Re: Addendum Number 2

RFQ C1543 – CoEd Residence Hall Bathroom Renovations Floors 9 - 10

Please find below a description and list of drawings which should be issued to the bidders as part of Addendum #2 for the Coed Bathroom Renovation on the 9th & 10th Floors:

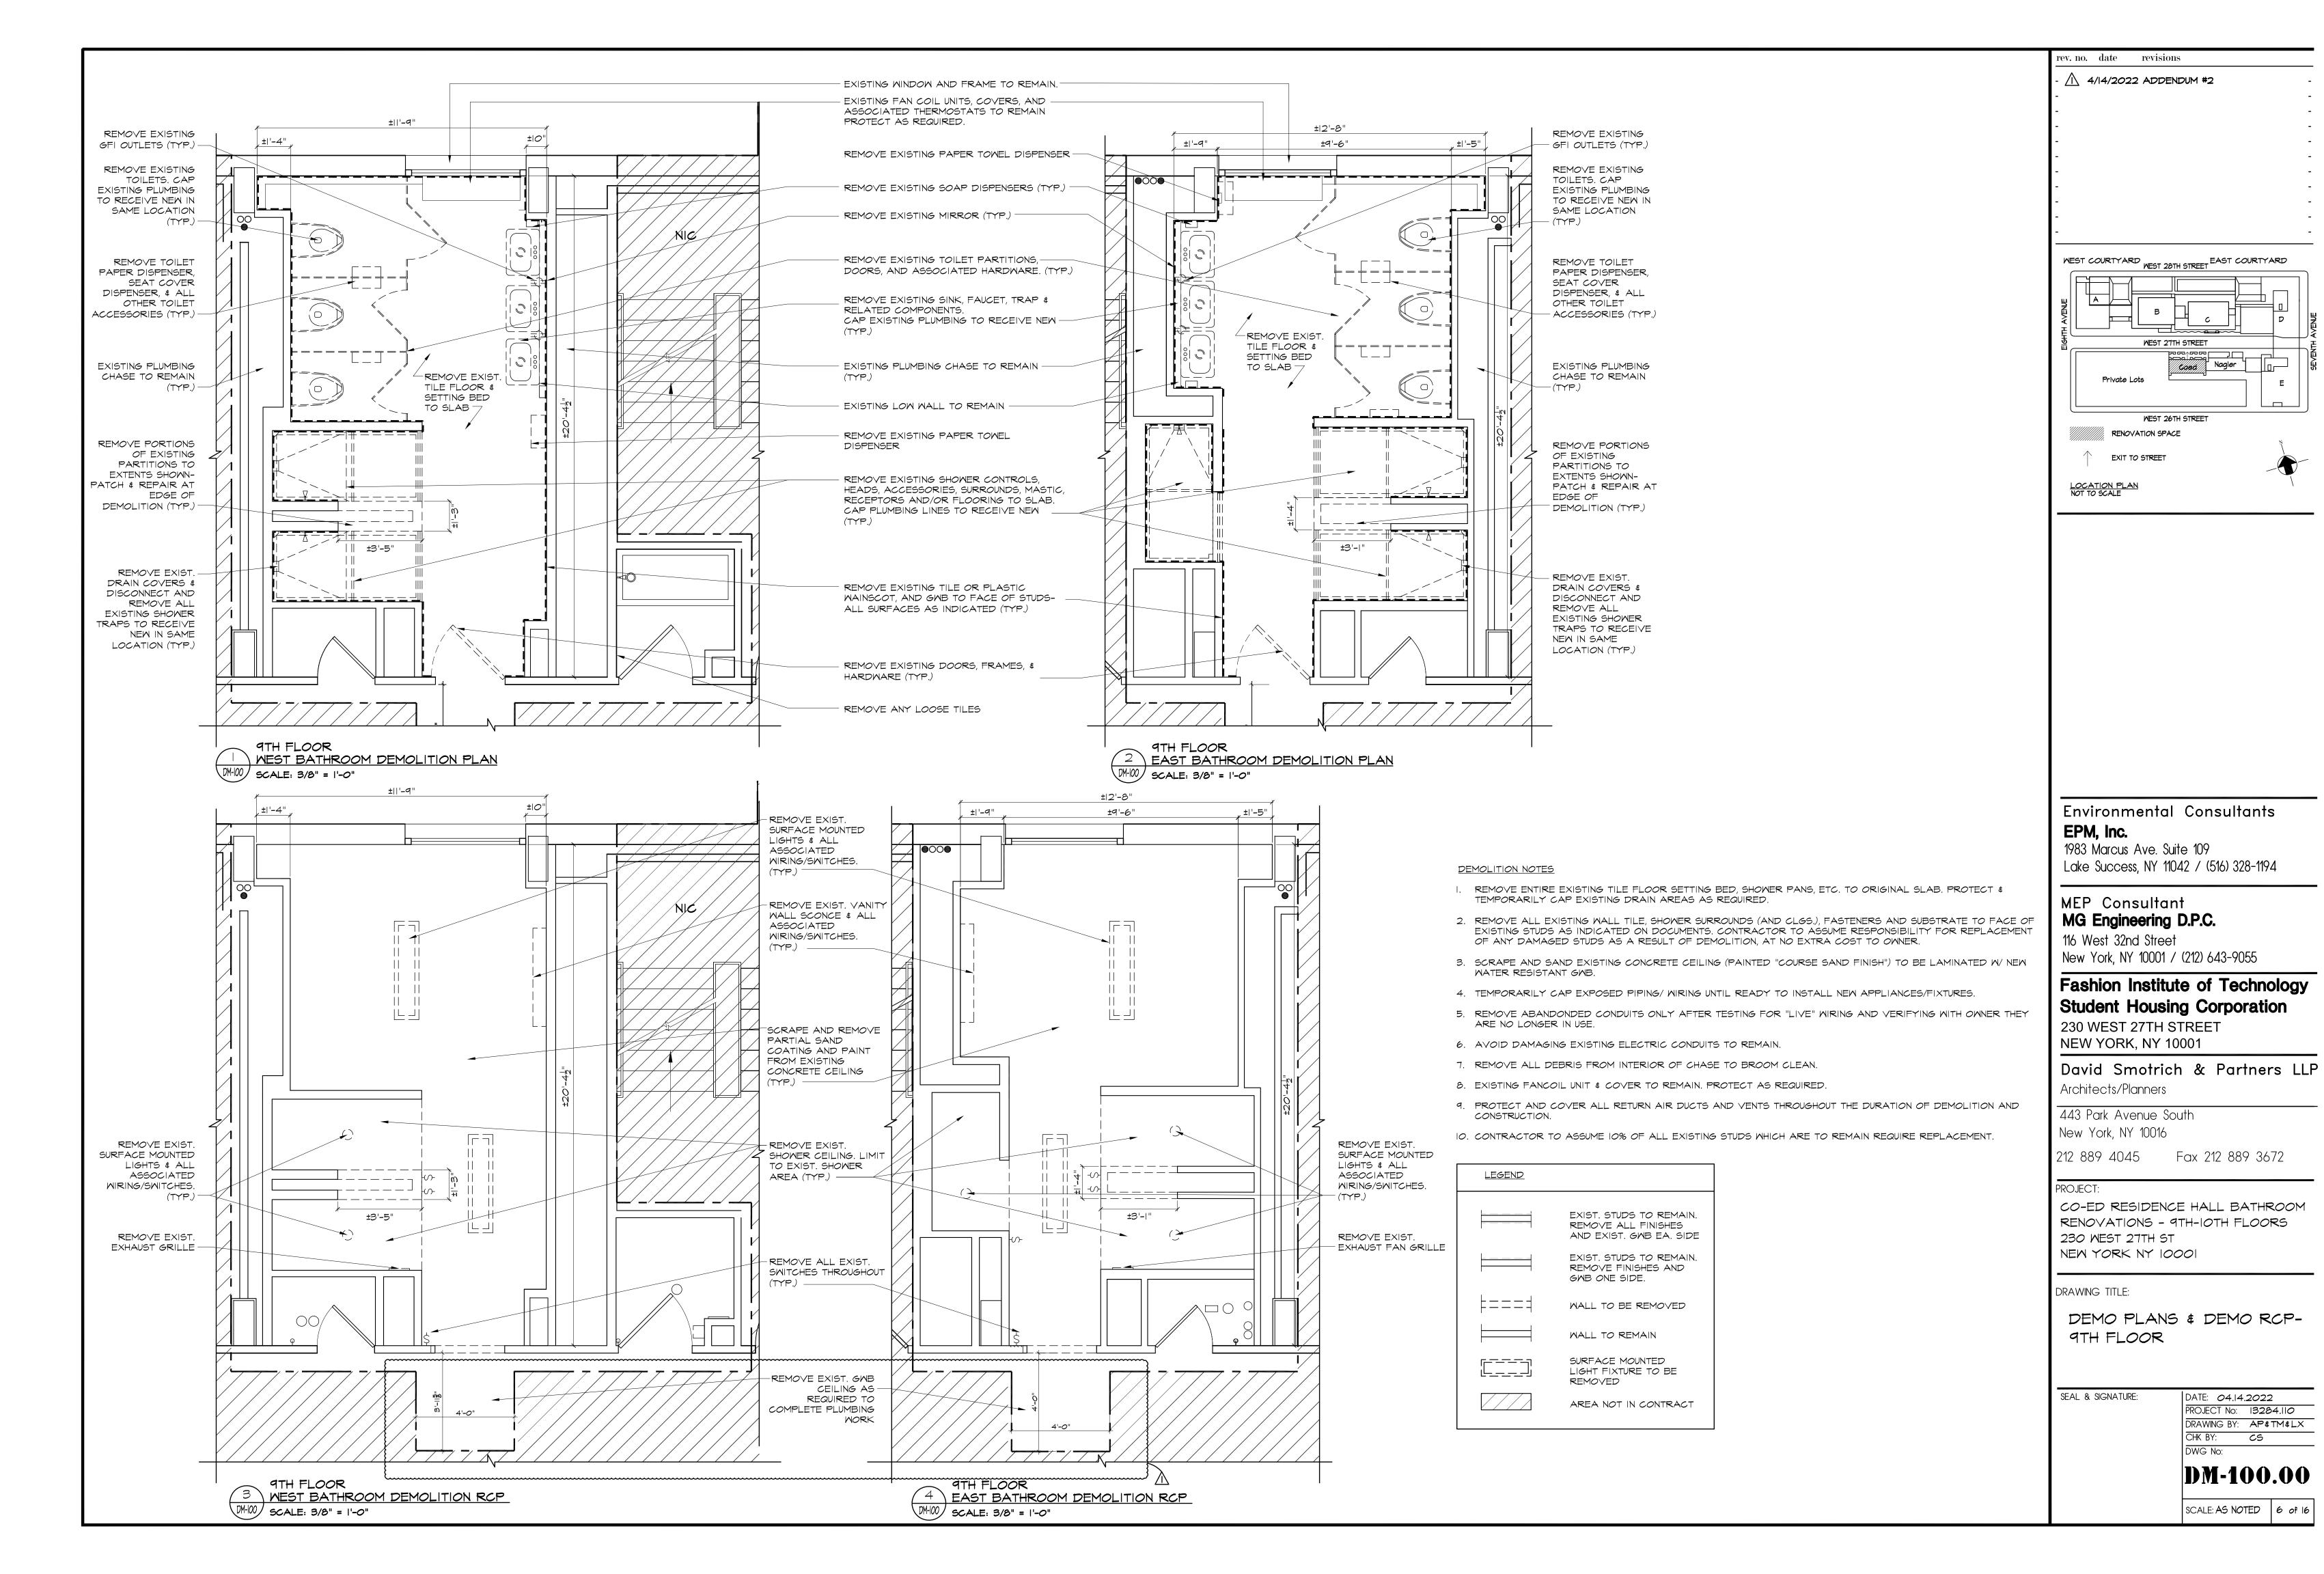
Q9. Regarding the upcoming bid for the Coed Residence Hall Bathroom Renovations, Floors 9-10 Project, Section 071613 "Cementitious Waterproofing", Page 2, Paragraph 2.01 A. is shown below. It cannot be bid by a contractor as written.

The products as specified do not exist or is not available as they are currently named and described.

- The "Thoroseal" brand was discontinued. Thoro Systems Products no longer exists.
- The "Sonoblock" brand was discontinued. Sonneborn Building Products no longer exists.
- BASF no longer manufacturers products of this type.

Consequently, there is no reference standard product for the contractor to bid.

The acceptable equivalent products for your specified need manufactured by UGL is "DRYLOK Powdered Masonry Waterproofer".

DRYLOK® PRODUCTS ARE PROUDLY MANUFACTURED IN SCRANTON, PA.
I respectfully request you update your specifications for future projects and consider DRYLOK
Powdered Masonry Waterproofer as an "or equal" in an upcoming Addendum.

A9. "DRYLOK Powdered Masonry Waterproofer" Is acceptable or equal.

P-100 SCALE : 1/4" = 1'-0"

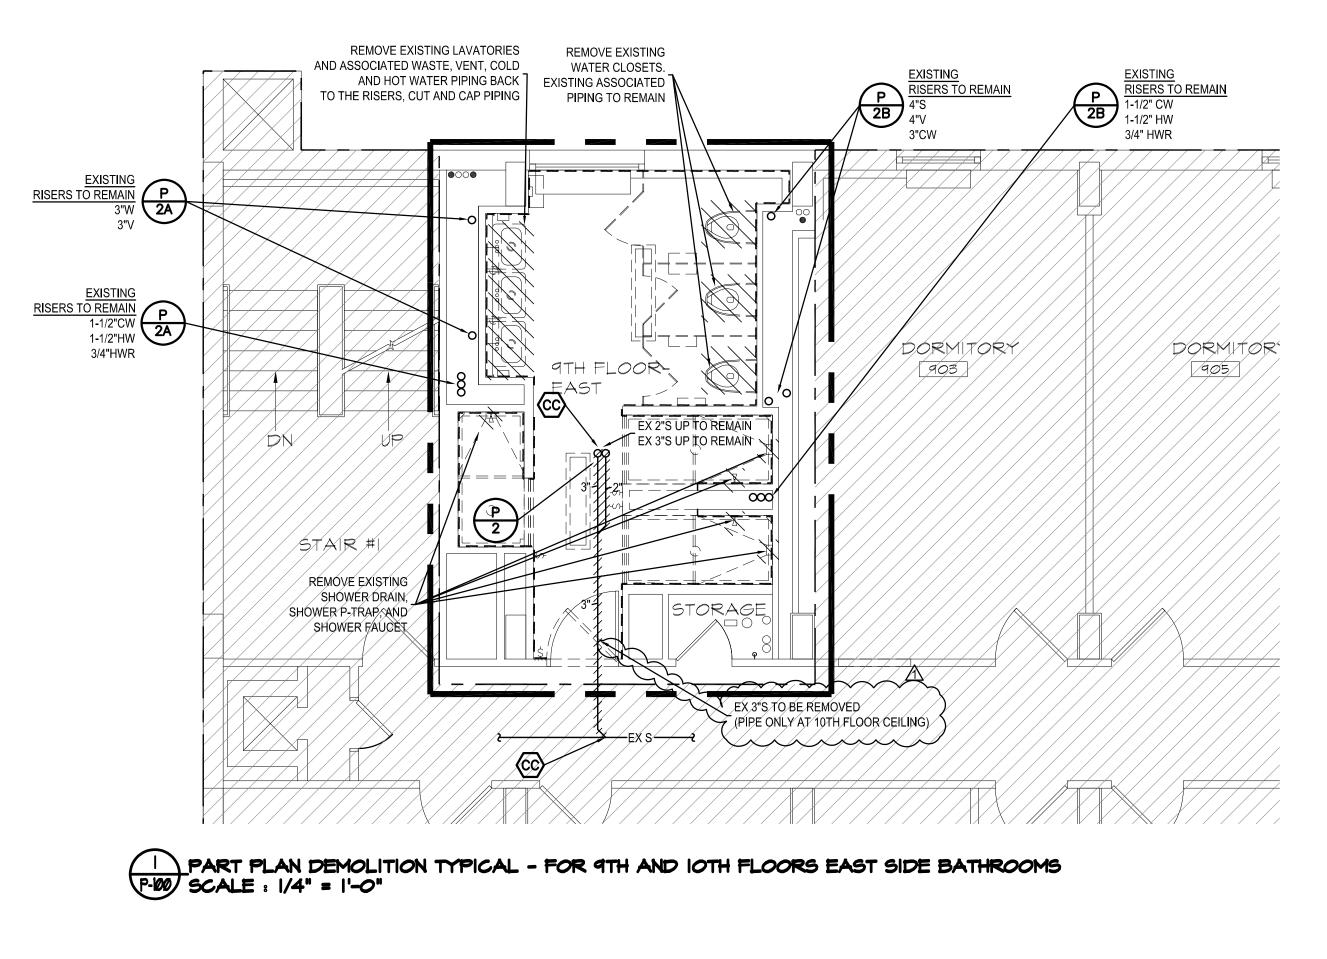
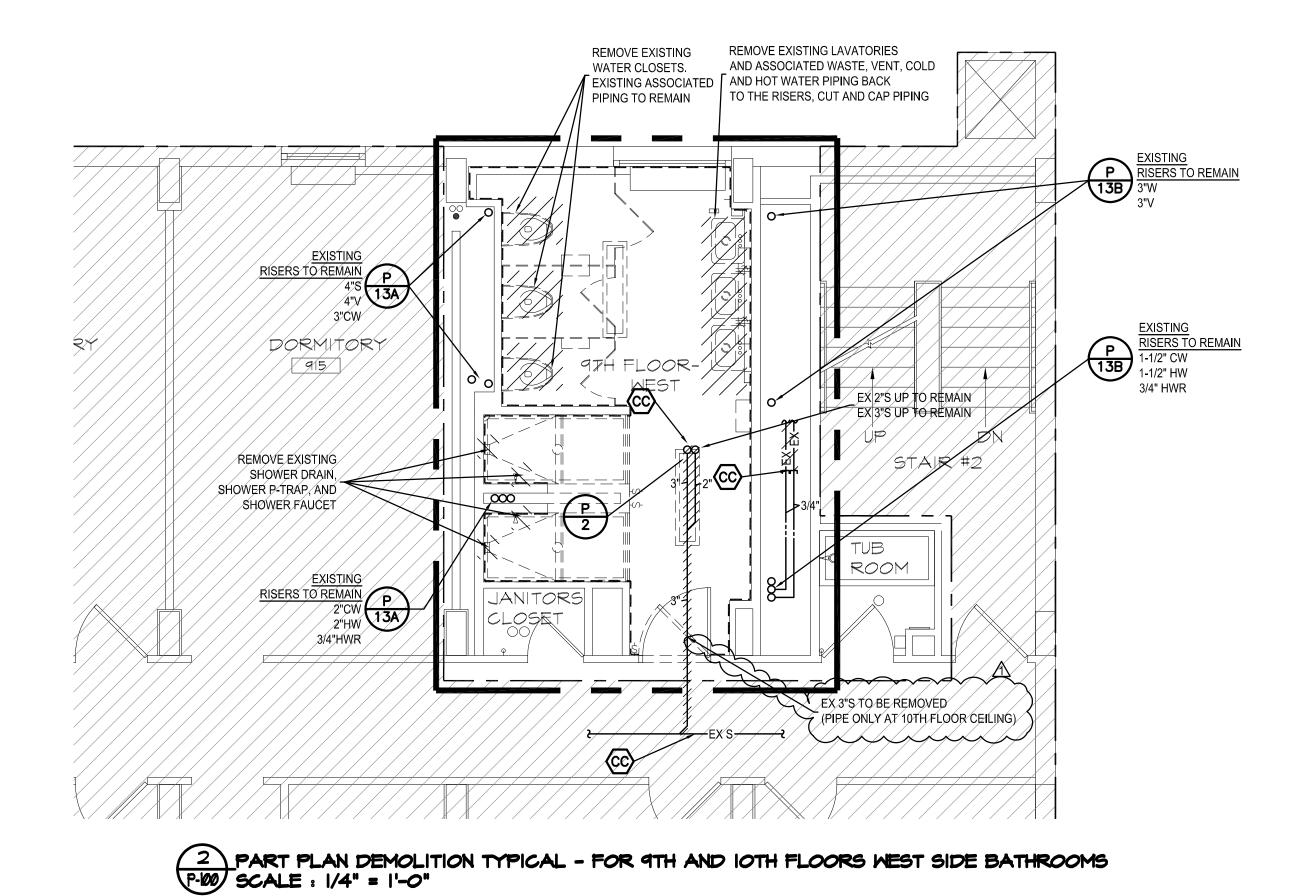
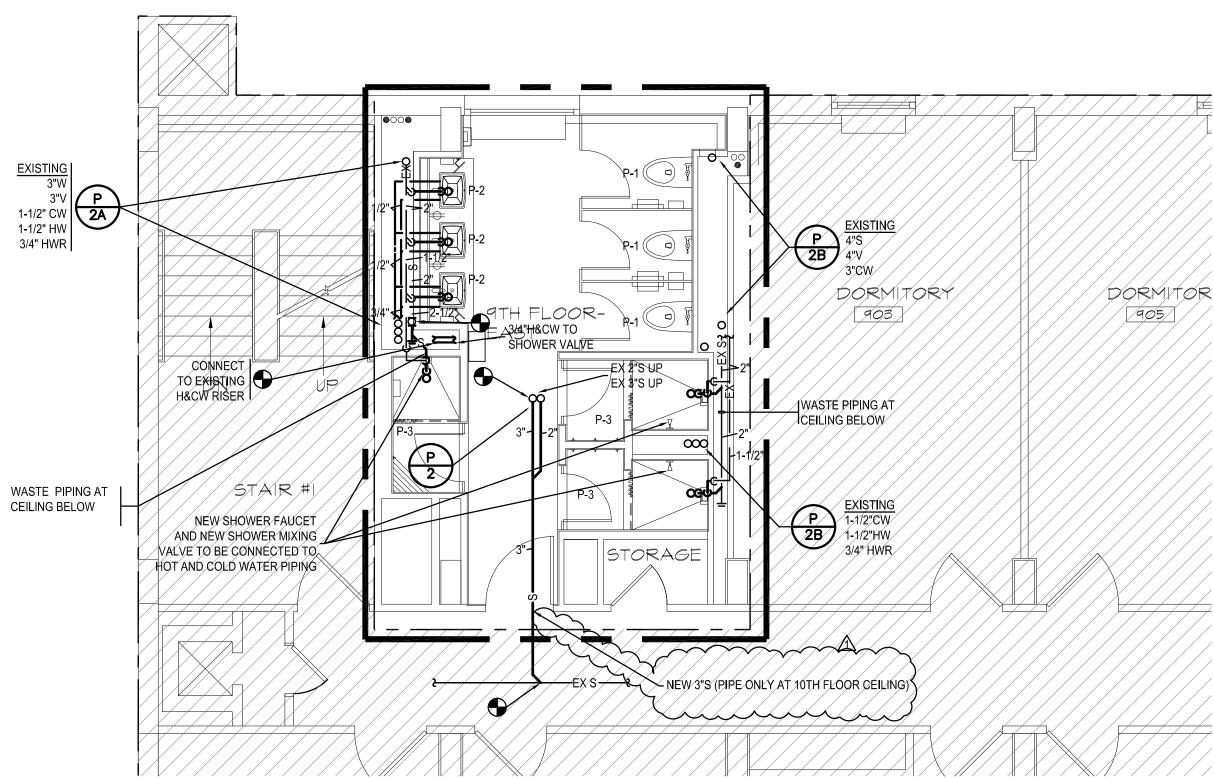
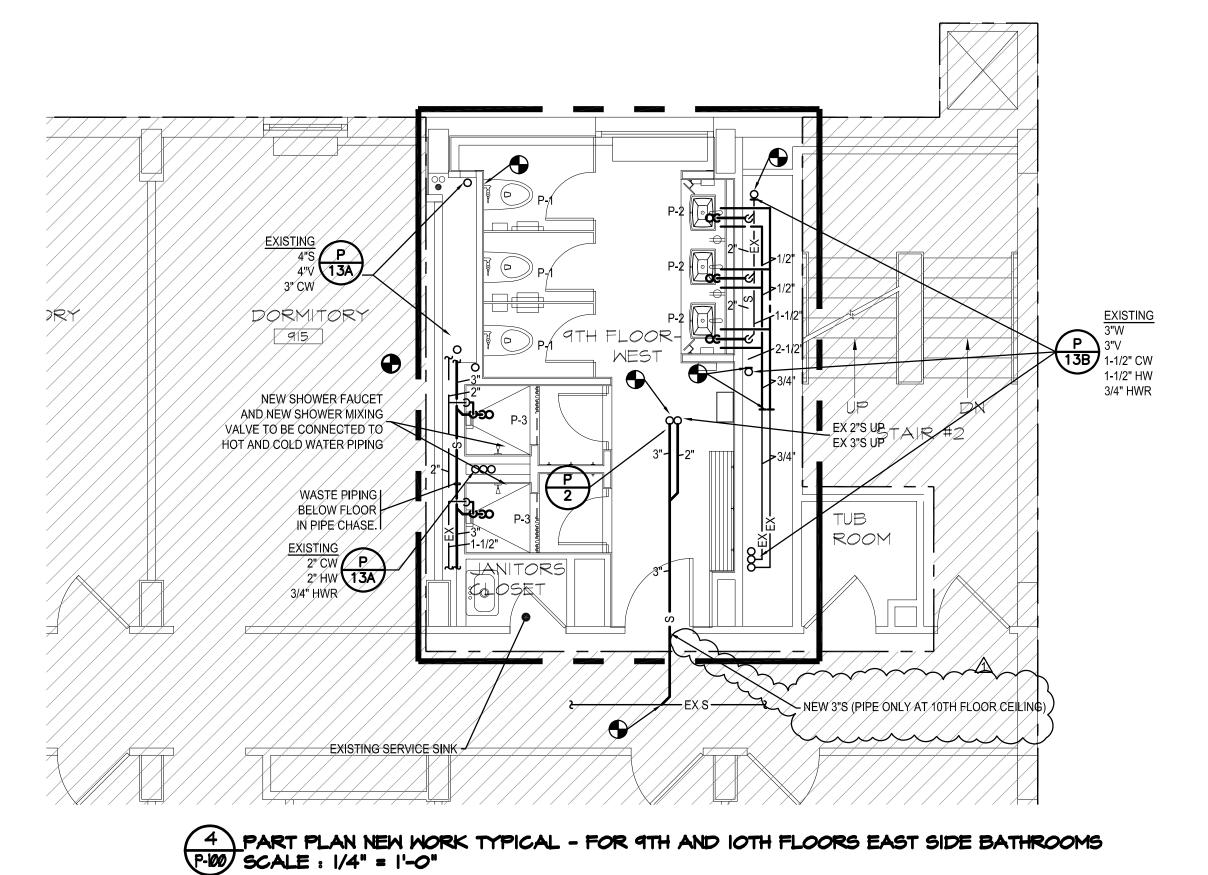
- 1. Drawing P-101 is being REMOVED from the set.
- 2. Revised P-100 and P-200 includes revised direction regarding the piping to the existing risers. Additionally see response to Question 5.

- Q4. Please confirm conditions of ceiling on floor below of 9th Floor.
- A4. See drawing A-104 which is being issued as part of this addendum.
- Q5. Please confirm how and where plumbing waste roughing are being run on floor below (plumbing riser diagram shows roughing being install on floor below) on 8th for 9th Floor bathroom and on 9th floor for 10th floor bathroom. According to site visit, it seems that all roughing is buried within slab.

SEE DWG P-200 FOR DETAILED SANITARY PIPING TO BE REPLACED

PROVIDE CARRIERS FOR NEW WC

- A5. For the WC and lavatory the roughing is running above the slab behind the wall on the same floor. For showers roughing is running below the slab, on the ceiling of the floor below. All the plumbing work is shown on the riser diagram.
